DRAFT ENVIRONMENTAL IMPACT REPORT

PROPOSED AMENDMENT OF THE APPEAL ENVIRONMENTAL AUTHORISATION ISSUED ON 18 AUGUST 2009 AND THE ENVIRONMENTAL MANAGEMENT PROGRAMMES FOR THE PROPOSED RESIDENTIAL DEVELOPMENT ON A PORTION OF THE FARM VAALE VALLEY 219, MOSSEL BAY – HARTLAND LIFESTYLE ESTATE

DEADP EA REF NO: 16/3/3/5/D6/29/0008/22

31 January 2025

Figure 4: Locality of proposed Telecommunication mast.

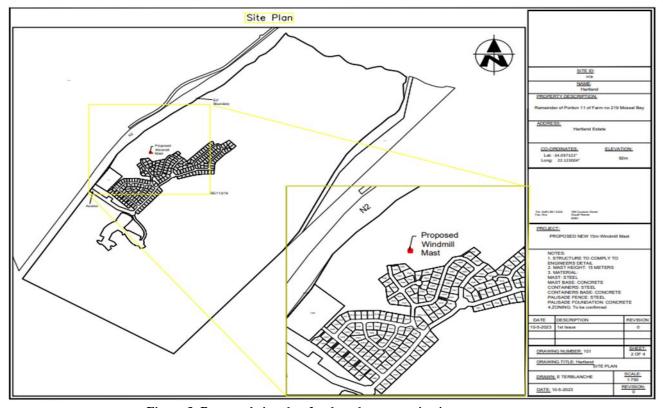
The Amended Operational EMPr Section 3.2: Description of proposed activity should also be amended to include Figures 4-7:
